UPDATE Technical Bulletin

72 12 01 July 12 2012 2029919

UPDATE – 72D8 Seat Linkage Bolts

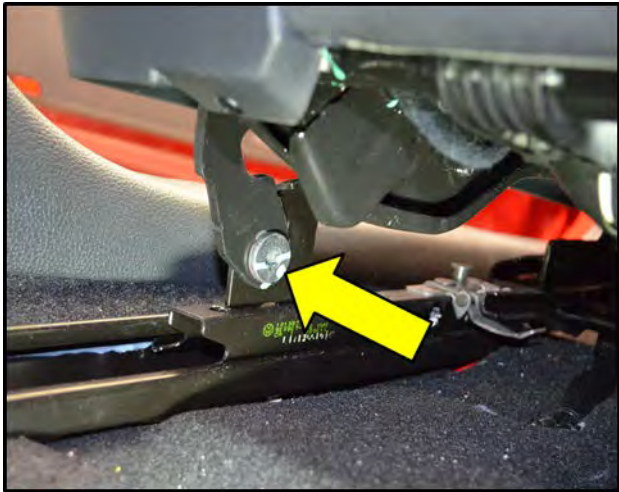
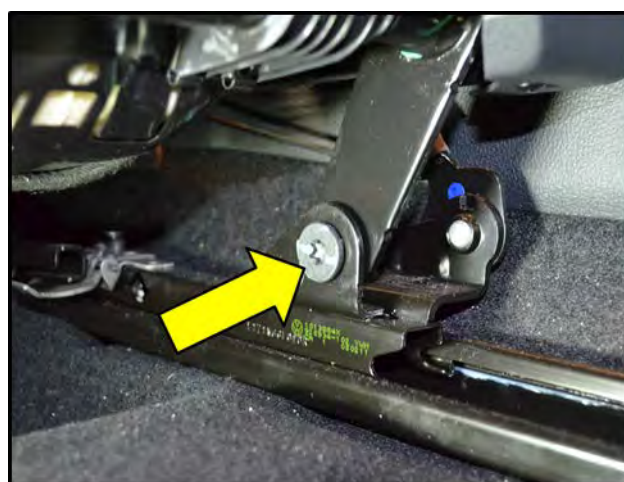
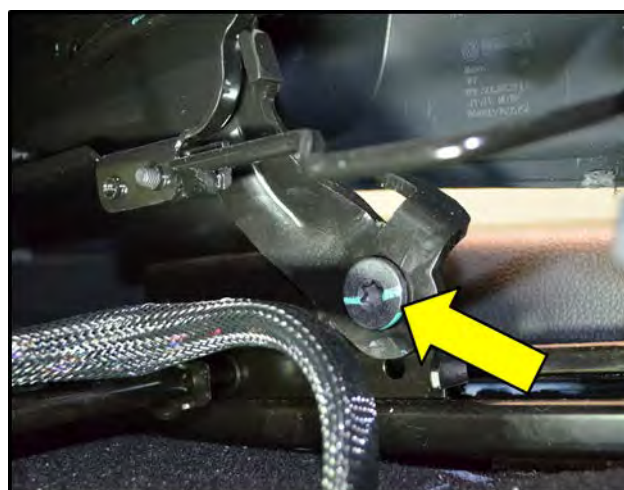
Tolerances between seat bolt (link screw) and seat bolt frame link pivot points may create squeaking noises while driving or while seat is being raised and lowered.

Install newly designed seat bolt (link screw).

<p>Tip: To make repair easier, perform procedure on one bolt at a time.</p> <ul style="list-style-type: none"> • Move front seat forward. ⇐ Adjust seat height so that the seat bolt (link screw) <arrow> is accessible. ⇐ On left rear of seat frame, remove screw <arrow> using T-50 torx. • In same location, install new screw and washer from parts kit (5C6 898 515) first by hand, then tighten with ratchet equipped with T50 torx bit. ⇐ Torque screw <arrow> to 26 Nm. 	Criteria	Repair	01 & 02	Both front seats	03	Driver seat only
Criteria	Repair						
01 & 02	Both front seats						
03	Driver seat only

- ⇐ On right rear of seat frame, remove screw <arrow> using T-50 torx.
- In same location, install new screw and washer from parts kit (5C6 898 515) first by hand, then tighten with ratchet equipped with T50 torx bit.
- ⇐ Torque screw <arrow> to 26 Nm.

- Move seat rearward so that the link screw <arrow> is accessible.
- ⇐ On left front of seat frame, remove screw <arrow> using T-50 torx.
- In same location, install new screw and washer from parts kit (5C6 898 515) first by hand, then tighten with ratchet equipped with T50 torx bit.
- ⇐ Torque screw <arrow> to 26 Nm.

- ⇐ On right front of seat frame, remove screw <arrow> using T-50 torx.
- In same location, install new screw and washer from parts kit (5C6 898 515) first by hand, then tighten with ratchet equipped with T50 torx bit.
- ⇐ Torque screw <arrow> to 26 Nm.
- Vehicles with criteria 01 and 02, Move to opposite front seat and perform all steps above.
- Vehicles with criteria 03 **WORK COMPLETE**
